Consideration of max_wait_timer

Comment # 315

Xuebo Wang, Guangcan Mi
Huawei

Figure 178B-10—Training control state diagram

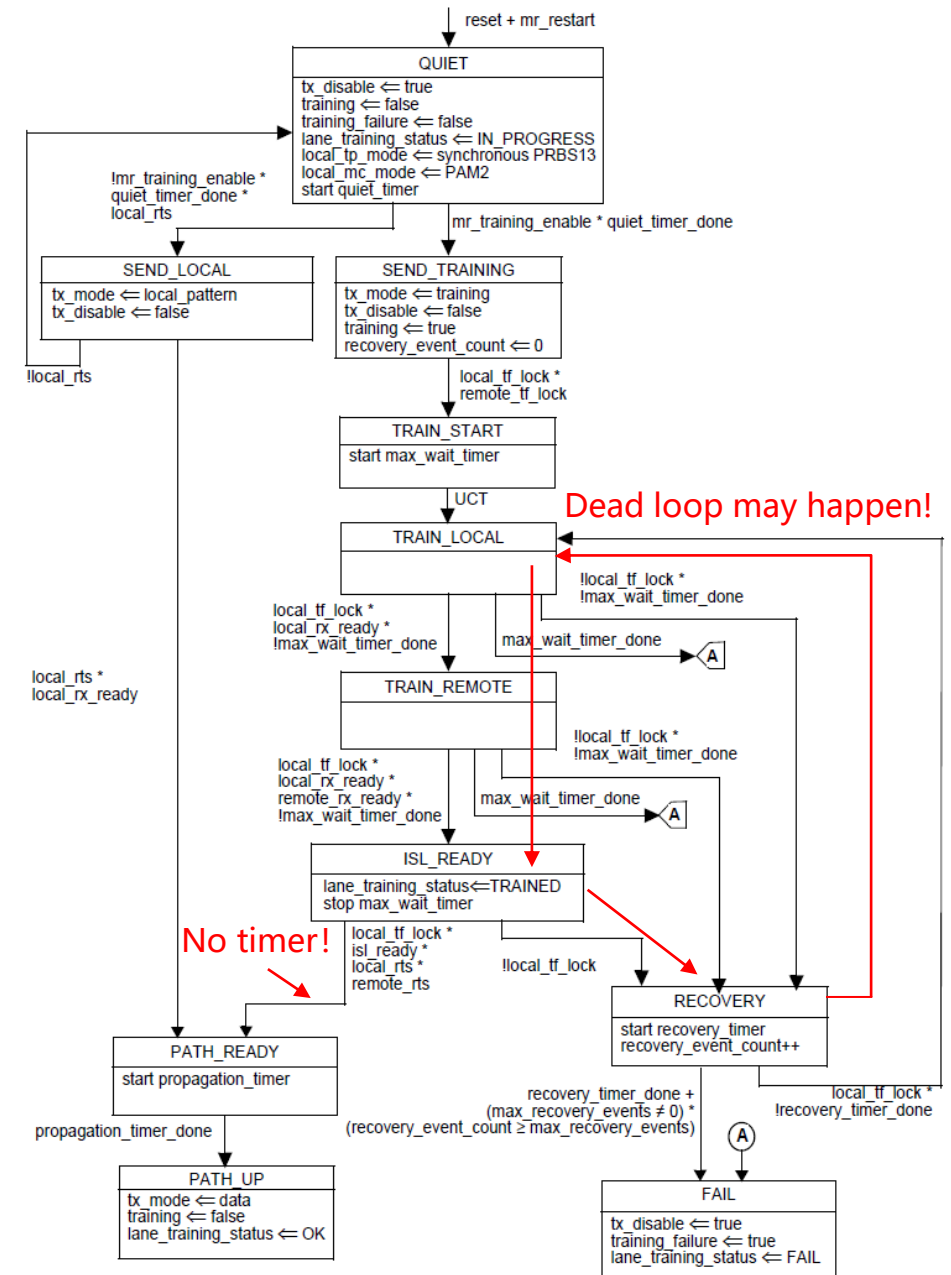
- No worries before ISL_READY. Time spent from TRAIN_LOCAL to ISL_READY with potential recovery is included.
- Once entering ISL_READY, **no timer used to bound ISL_READY→PATH_READY**. If local_rts or remote_rts keeps false due to disconnected interfaces or interruption on other ISLs,
 - **Path start up cannot be achieved before debugging.**
 - **A dead loop may exist** when training frame lock is often lost and its recovery time never exceeds the limit of recovery_timer with max_recovery_events = 0.**(ISL_READY→RECOVERY→TRAIN_LOCAL→...→ ISL_READY)**

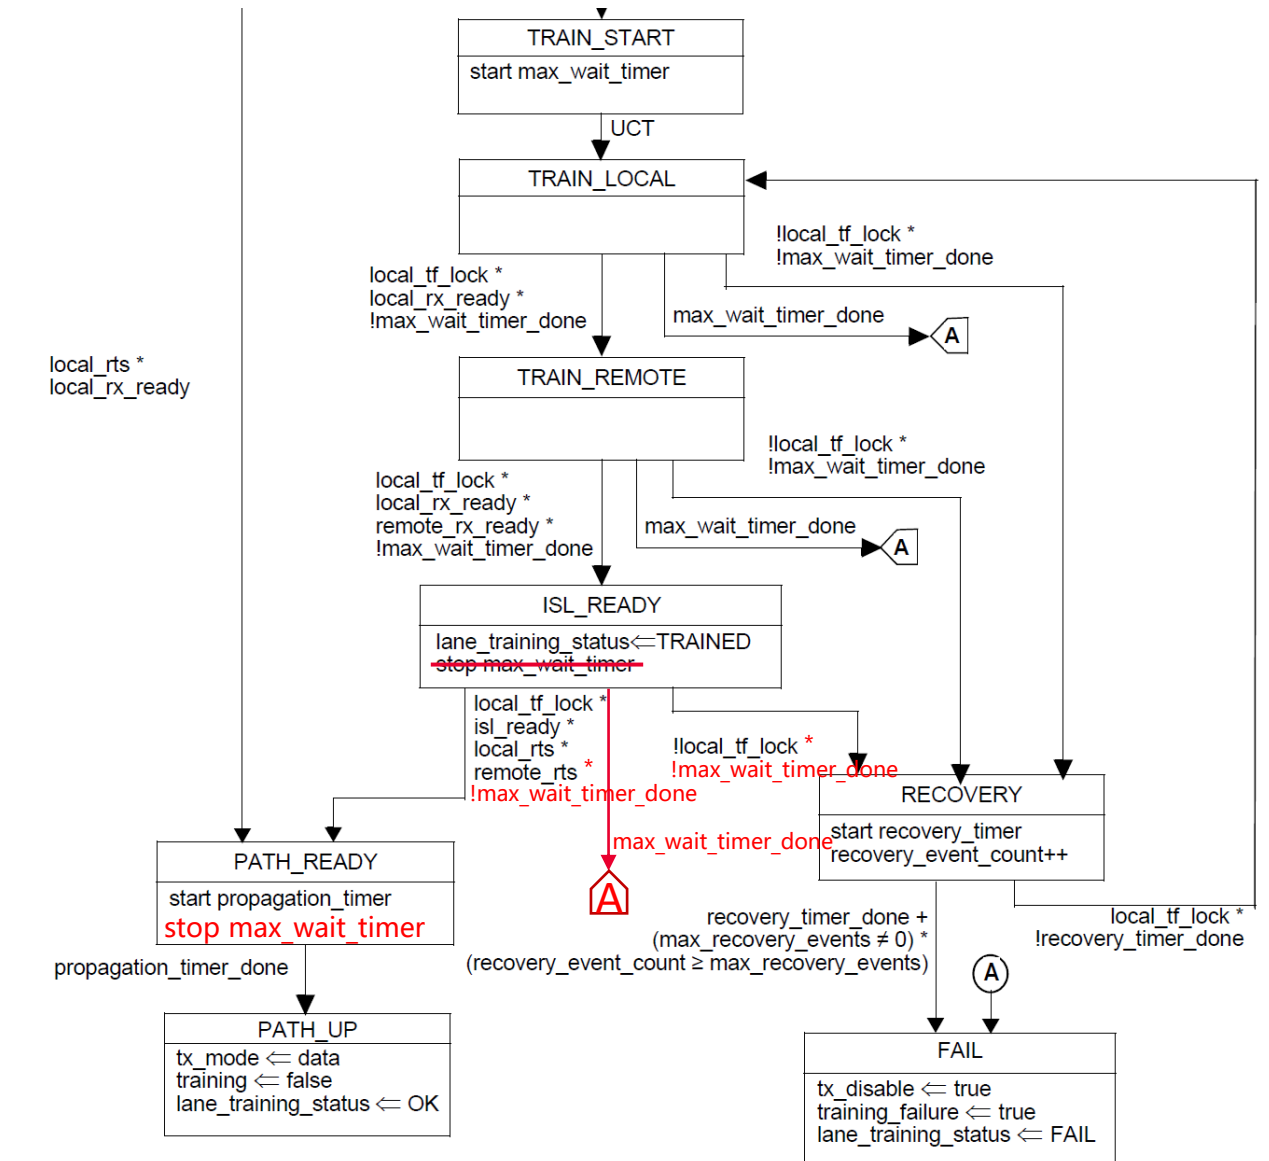
Changes:

- Stop max_wait_timer in PATH_READY instead of ISL_READY.
- Add “!max_wait_timer_done” condition for the transition from ISL_READY to PATH_READY or RECOVERY.
- Add new transition from ISL_READY to FAIL when max_wait_timer_done = true.

- Indicate users to debug if ISL_READY → PATH_READY has timeout to FAIL.
 - Training will restart only after debugging.
- max_wait_timer_done makes effect for all possible recovery loops.
- Minimum change to FSM.
